ADDENDUM NO. 5

Date: May 5, 2011
To: Shortlisted Contractors
From: Matthias Mueller - Project Manager
Reference: Residential Halls Buildings 2 and 3
Weber State University – Ogden, Utah
DFCM Project No. 10176810 and 11008810

**Addendum No. Five
for the
Weber State University
Residential Life Phase II - Buildings 2 and 3
DFCM Project Nos. 10176810 and 11008810
MHTN Project No. 2010543**

SHEET NUMBER
CD-002
ADD05-C1

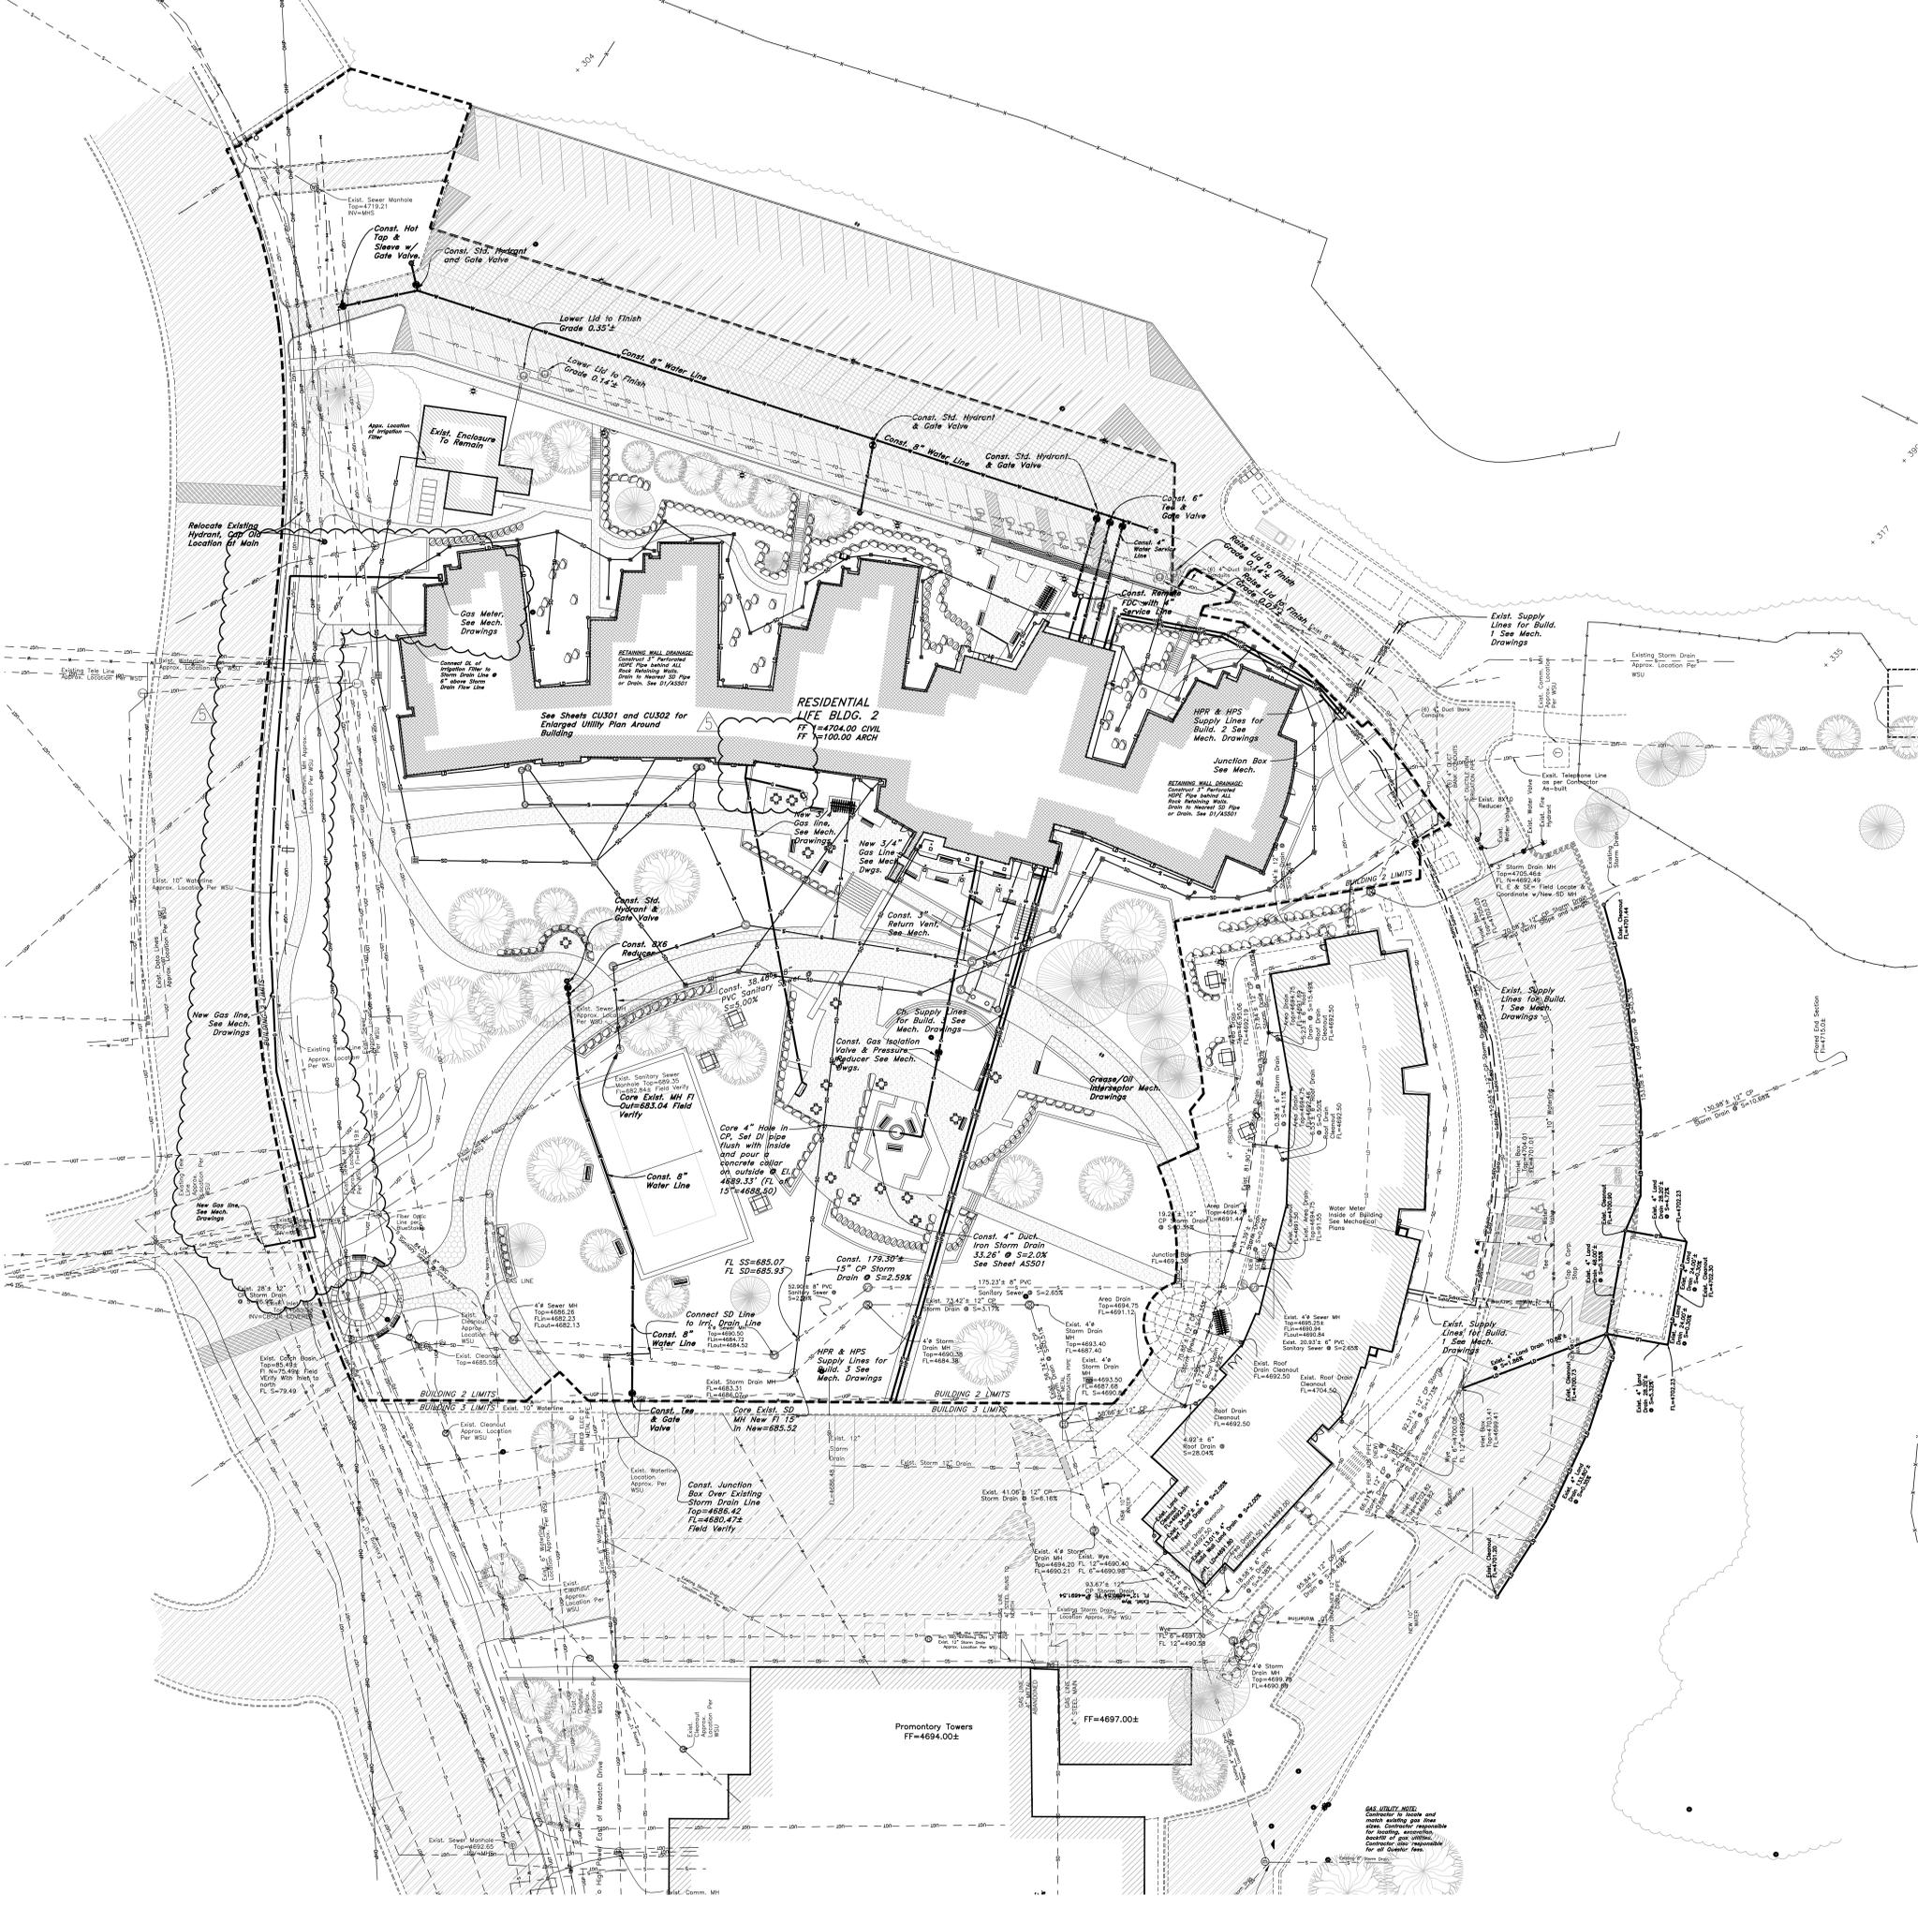
Question # 29: CD-002 Unable to read/decipher overlapping data points. Please remove overlaps or rearrange data point on drawing.

- 1. CD-002: Remove and arrange existing spot elevations for drawings clarity. See attached drawing ADD05-C1
- 2. CU-301: Relocated Gas Meter from south side of building to the north side of the building. See attached drawing ADD05-C2

Answer: See Changes to Drawings below.

A
SF104A

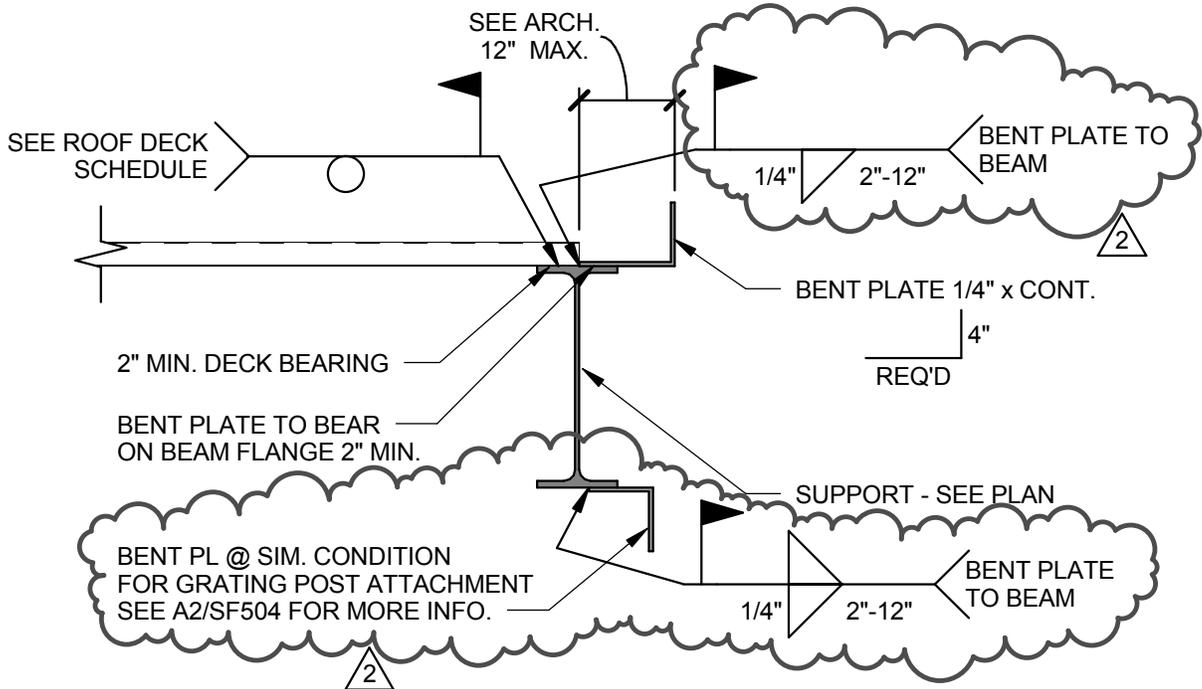
-A detail cut was revised. Please see the attached sheet AD05_S01.

SHEET NUMBER
AD05-A02
 SHEET REFERENCE
 AE505

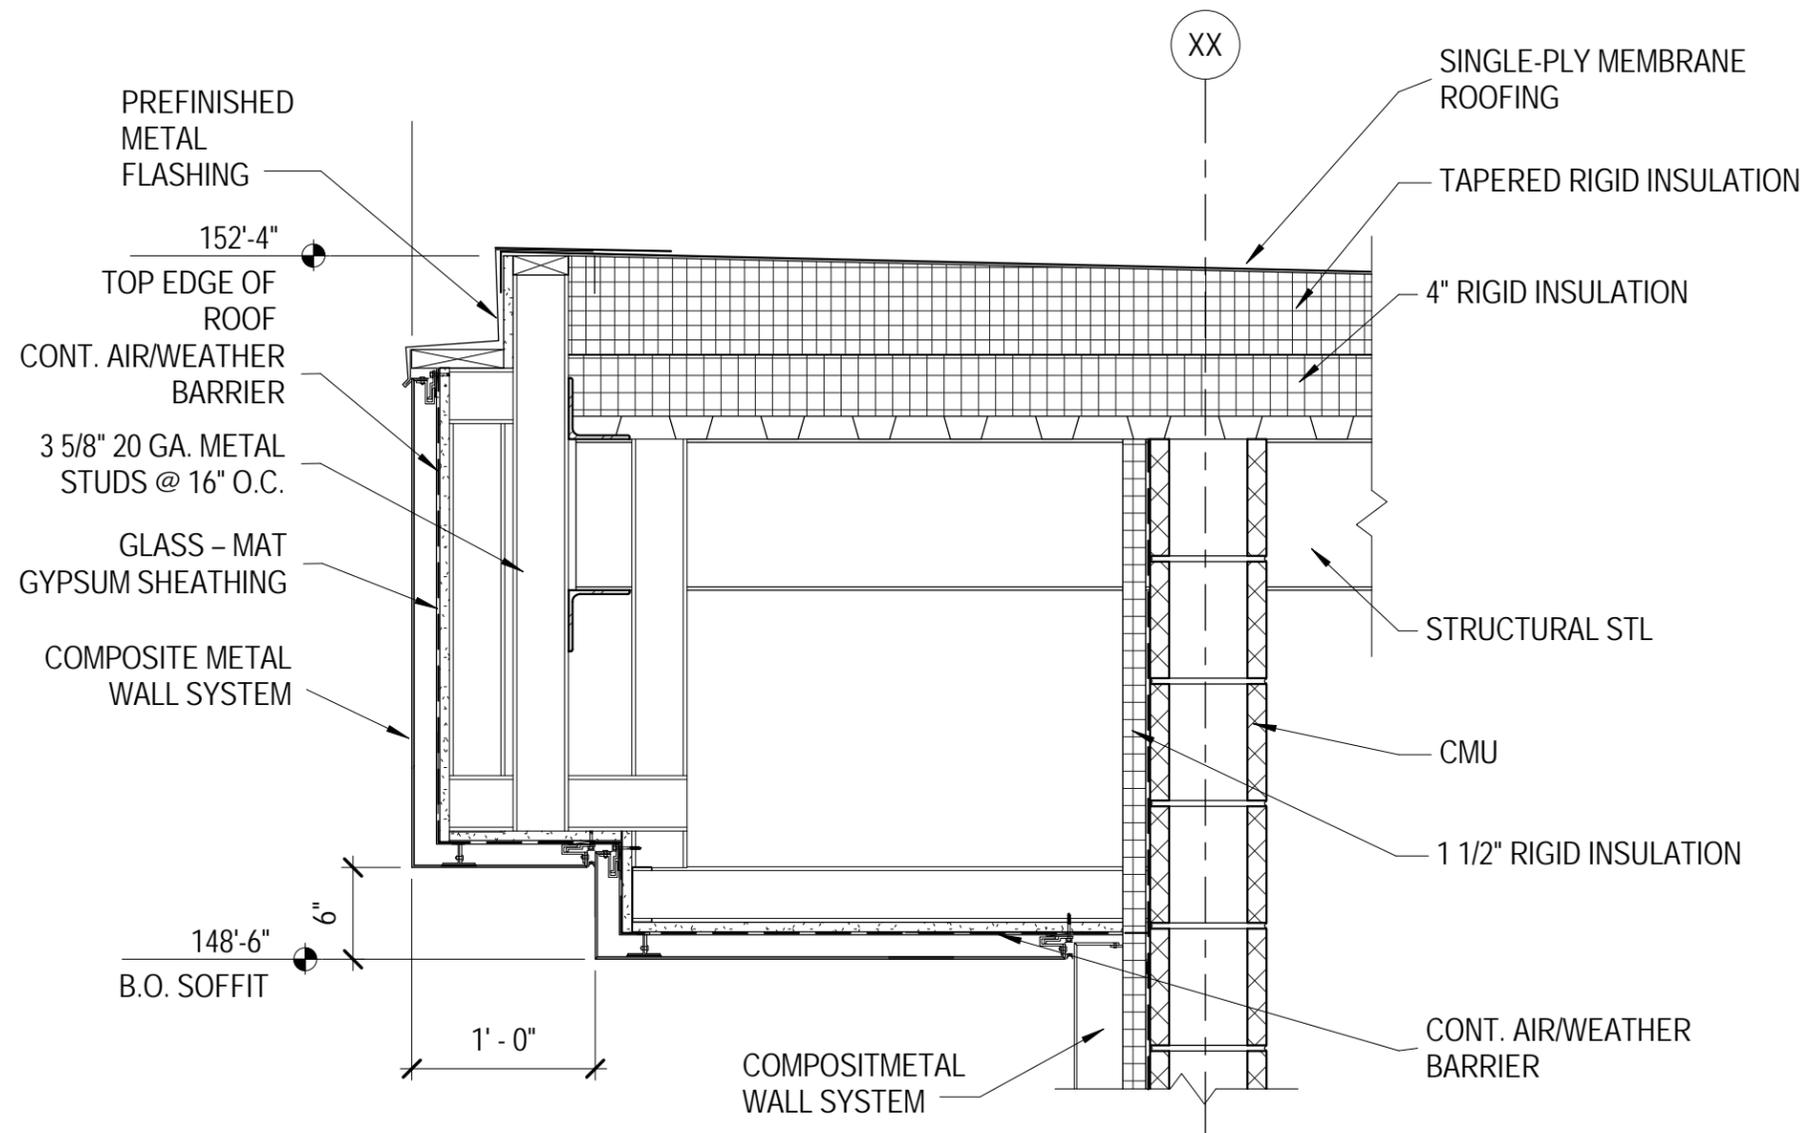
- A. Revise details D1 & C1/AE505 to show continuous air/weather barrier as shown. Delete note "30 lb BUILDING FELT". See Sheets AD05-A02 & AD05-A03

D1
SB501

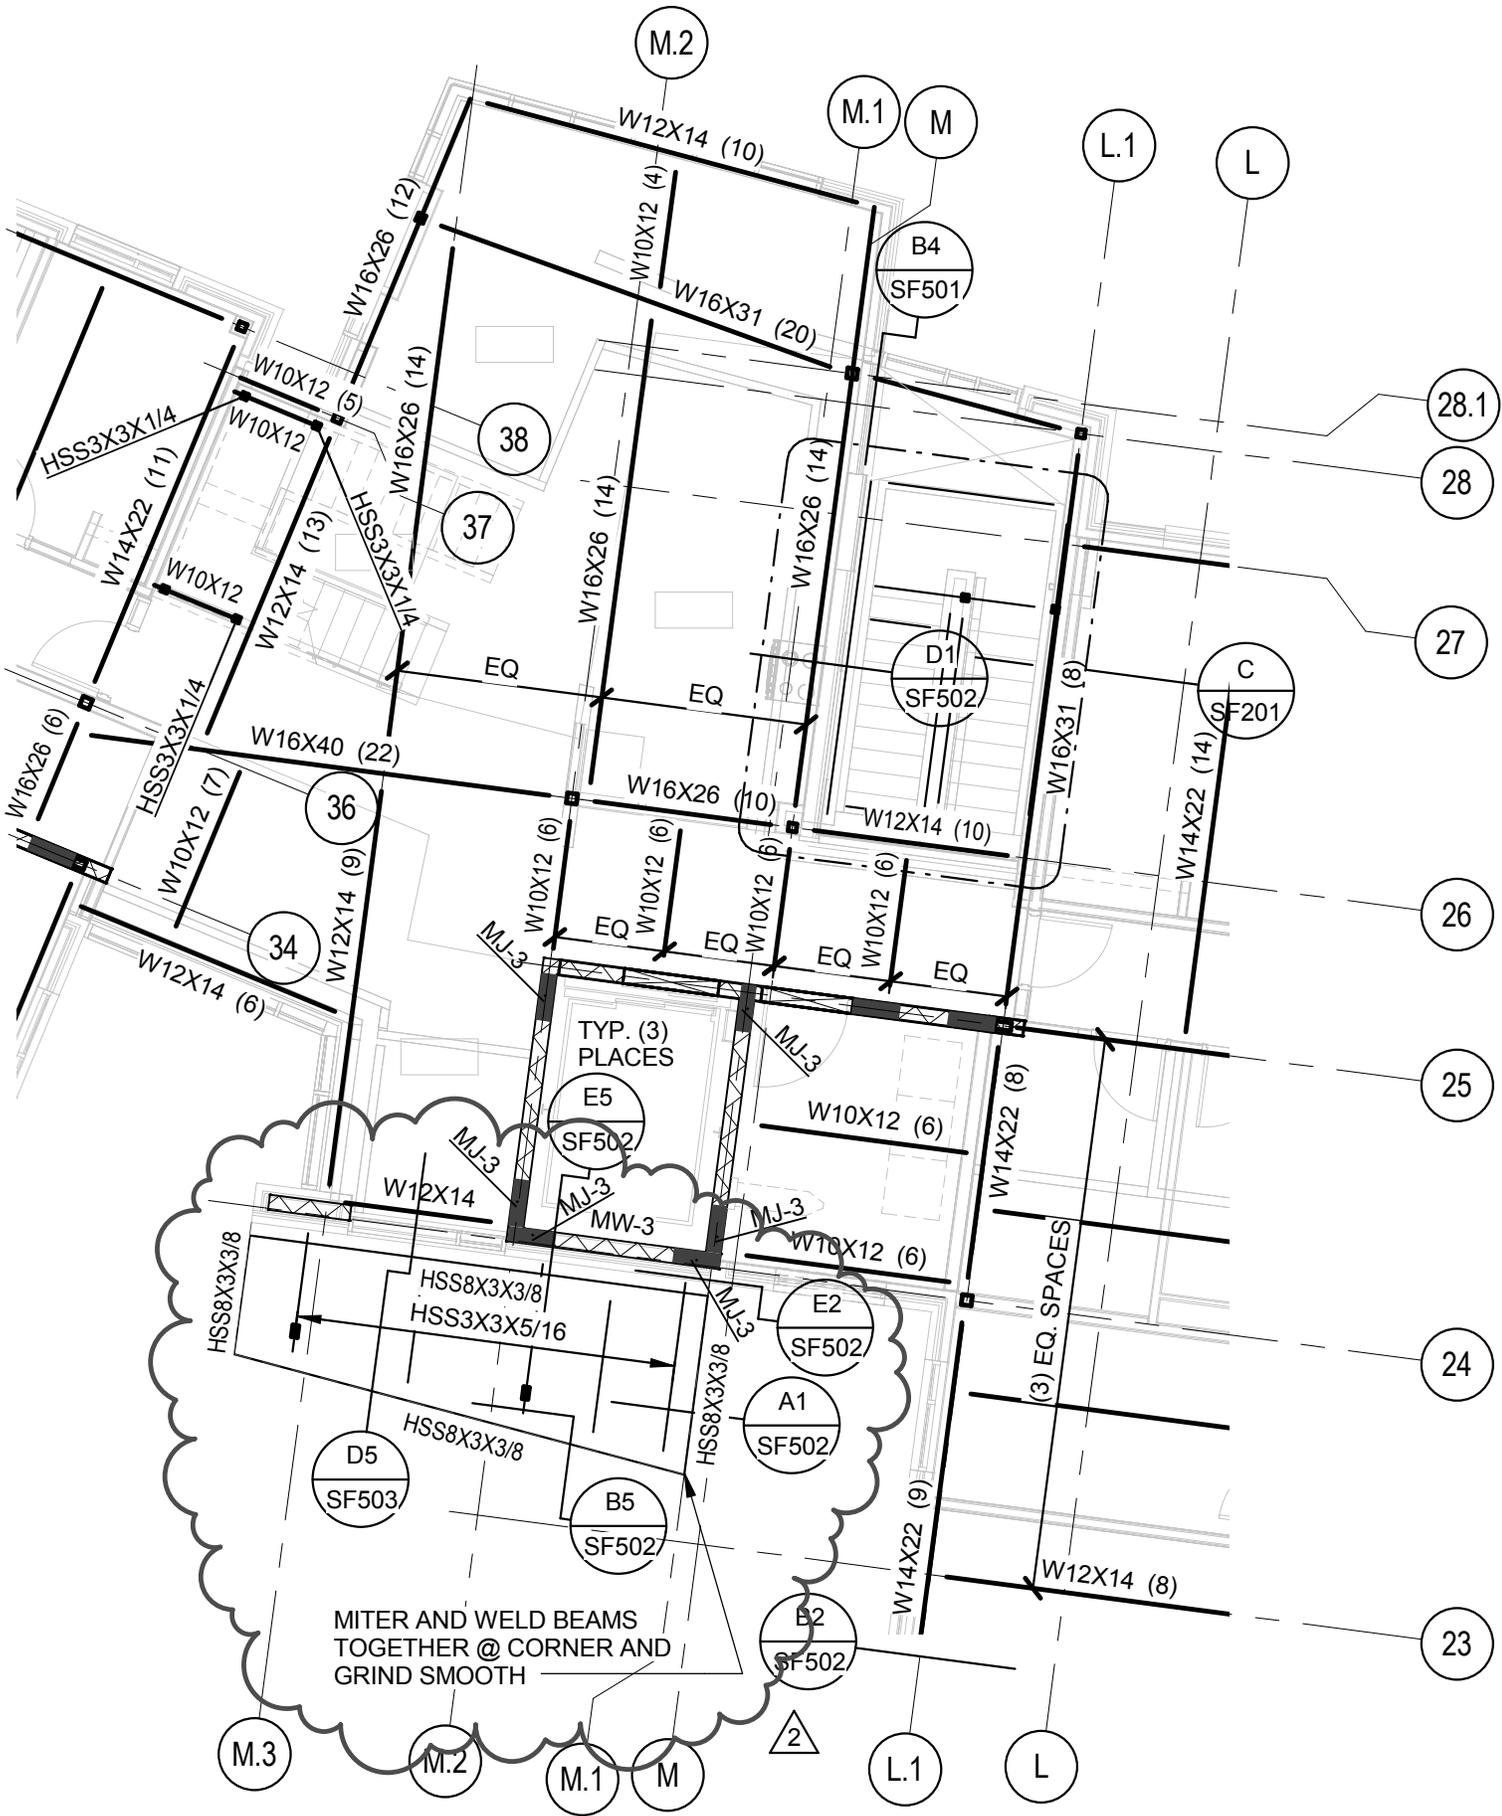
-Detail D1/SB501 has been revised. Please see the attached sheet AD05_S02.

SHEET NUMBER
AD05_S03
 SHEET REFERENCE
SF102

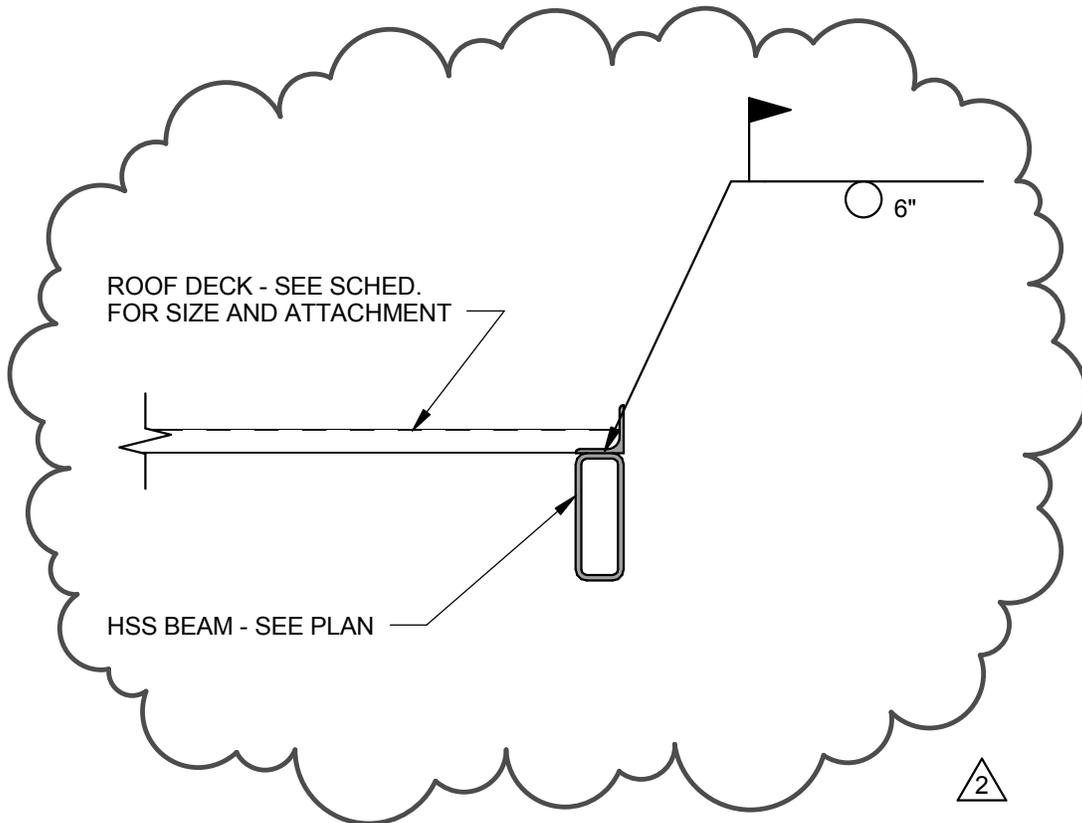
-The framing plan for the west canopy has been revised. Please see the attached sheet AD05_S03.

A1
SF502

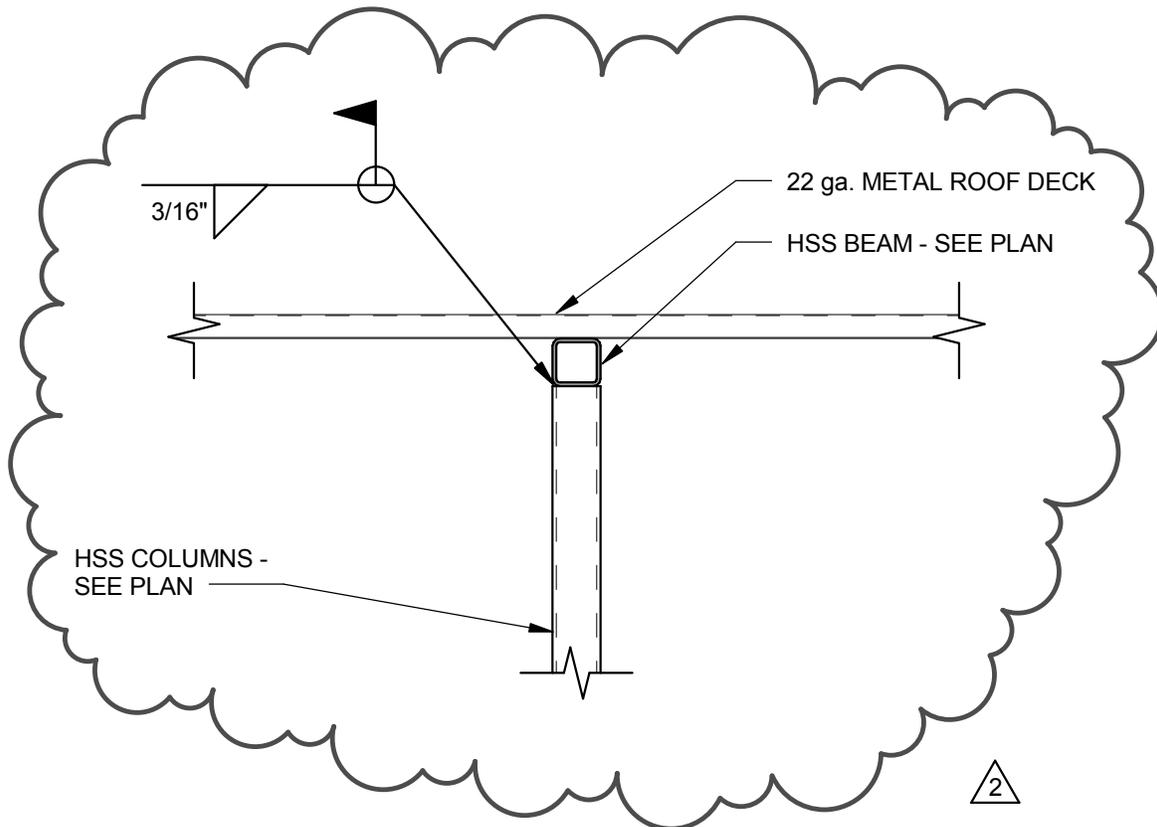
-Detail A1/SF502 has been revised. Please see the attached sheet AD05_S04.
